**Subject:** feedback on remaining parcels; map errors

Thank you for working through the remaining areas on the Future Land Use Map. Please consider the following feedback on the staff memo and other issues as you proceed:

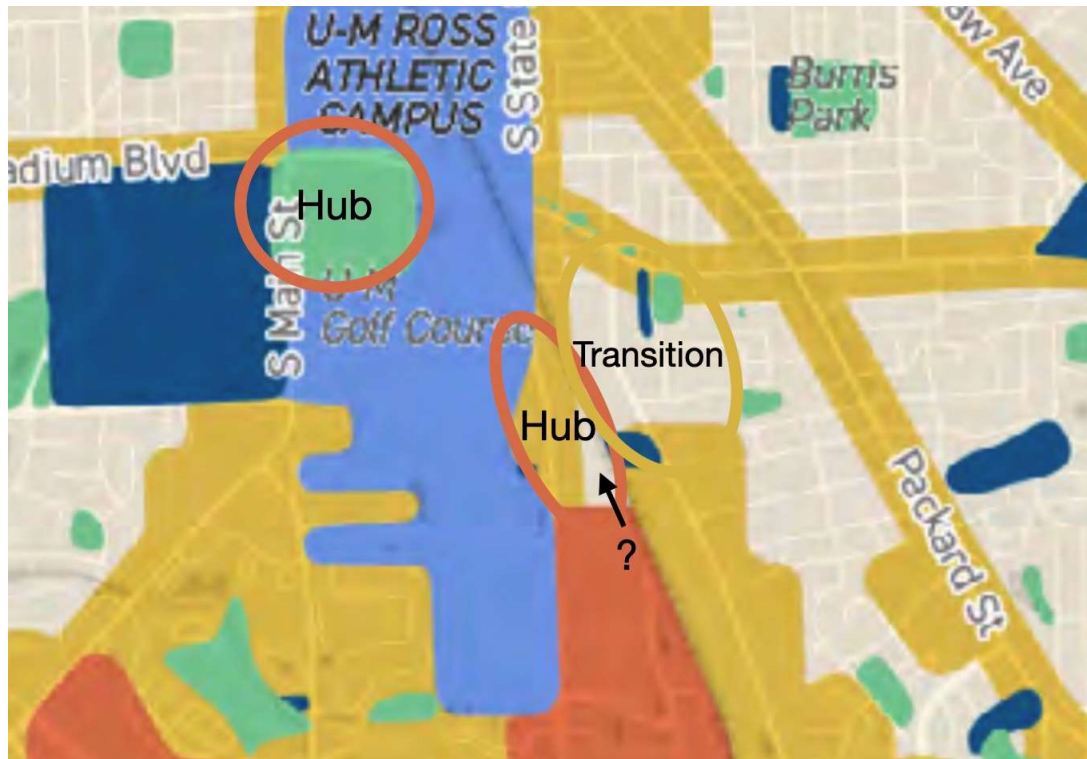
Your current draft states that Transition tapers specifically to 3 stories. (I'm assuming it's your desire to mandate that this district, when zoned, will in fact limit heights to 3 stories when next to Residential.) Depending on how gradual or sudden the taper is determined to be in the zoning process, *it may not in practice allow additional floors in some small/narrow Transition neighborhoods surrounded by Residential (such as Hillside Terrace).*

But even with the same or similar height as the surrounding Residential zone, there are significant benefits of categorizing areas Transition instead of Residential: 1) denser residential opportunities (longer buildings, smaller setbacks internal to the zone) and 2) more types of commercial uses allowed. What a great opportunity to bring walkable retail to the surrounding neighborhoods and the density to support it!

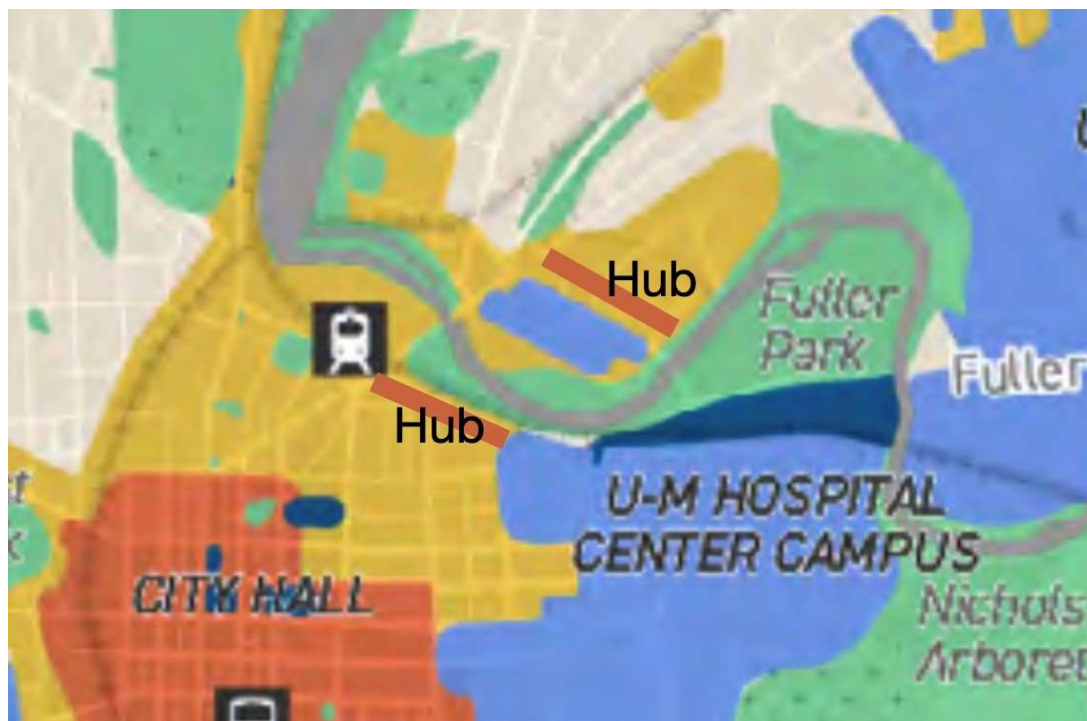
The State St Hub district should not arbitrarily stop as it nears Central Campus. Move all of State St south of the RR (Biercamp and Produce Station) into Hub.

Consider placing Maiden Lane (Beekman to Island Park), Broadway, Depot St and AAGAO into Hub. High rises should be allowed by-right in these areas.
